SERVICE BULLETIN

SUBJECT: TR-2400 Tone Encoder RFI

DATE 12/14/79

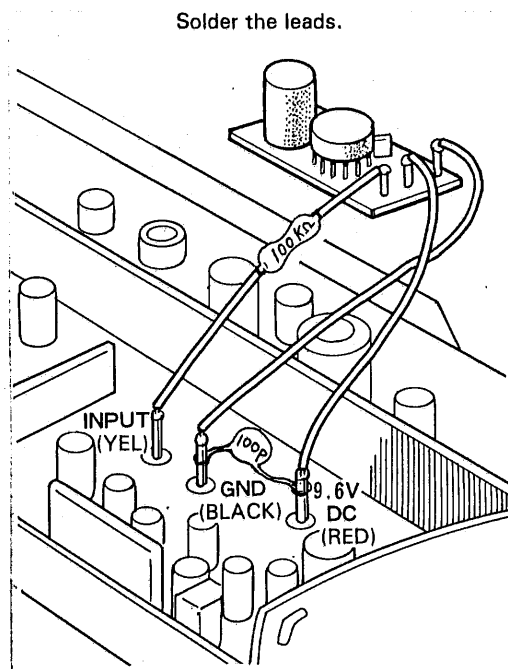
In some cases, users may report RF interference, or motor-boating, when using a Tone encoder in their TR-2400. A secondary complaint of excessive tone may also be encountered.

1. For RFI, bypass the B+ terminal to ground with a 100;F cap.
2. For excessive tone input to the TR-2400, install a 100K ohm resistor between the encoder and the TR-2400 Tone input terminal.
